MCARTHUR RIVER MINE OVERBURDEN MANAGEMENT PROJECT EIS REVIEW

MAY 2017
Report No. 01164E_1_v2

**McArthur River Mine Overburden Management Project
EIS Review
EIS Review Report**

Figure 6.1 – Flood Frequency Analysis Results for McArthur River at MIM Pump Gauging Station

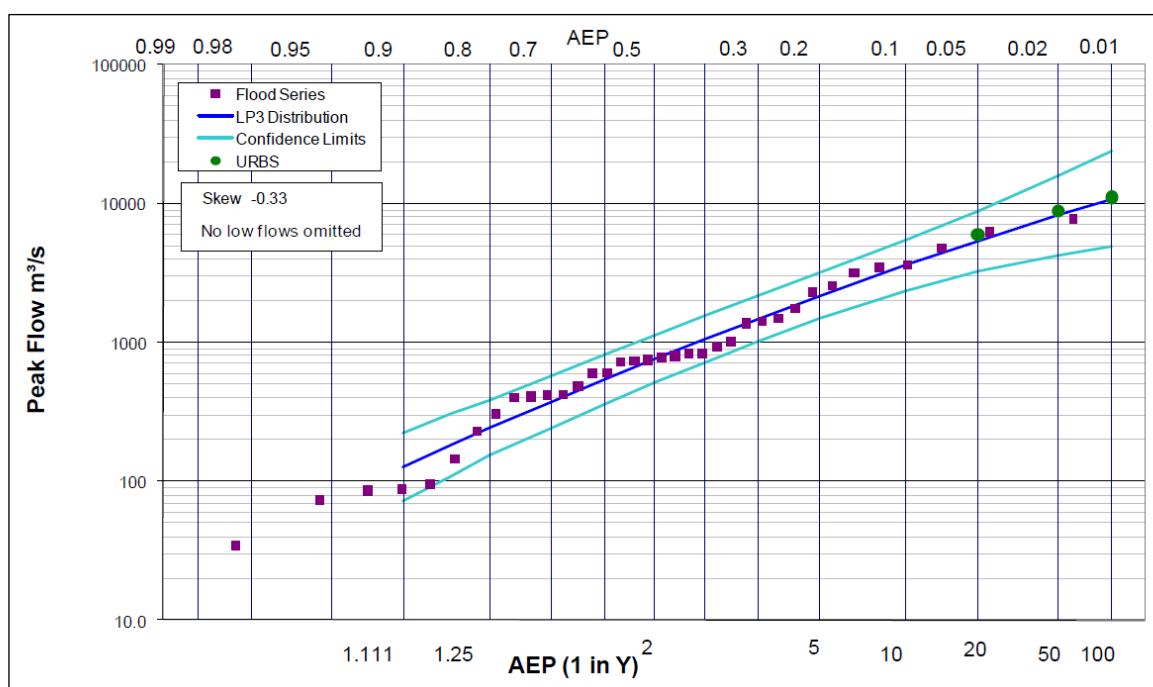
It is widely accepted that there is substantial uncertainty in flood magnitude estimates. For example, consideration and management of this uncertainty is a common theme throughout the revised Australian Rainfall and Runoff (ARR) (Ball et al., 2016a); with an entire chapter devoted to the subject (Ball et al., 2016b). The flood frequency analysis (FFA) adopted for the Phase 3 EIS provides a good example of the uncertainty in flood magnitude estimation. Consider Figure 6.1:

flood magnitude estimate means that it could easily be as large as the adopted 0.1% (1-in-1,000) AEP flood.

The 95% confidence limits shown in Figure 6.1 are a measure of the line of best fit to the observed data. That is, the fit assumes the observations are correct. It is widely accepted that there are a large number of possible errors/uncertainties in the observed data (e.g., rating curve error/extrapolation, non-stationarity in the catchment characteristics or climate, length of record) (See Kuczera and Franks (2016) for further examples). It follows that the actual uncertainty in FFA estimates are likely to be much larger than those shown in Figure 6.1.
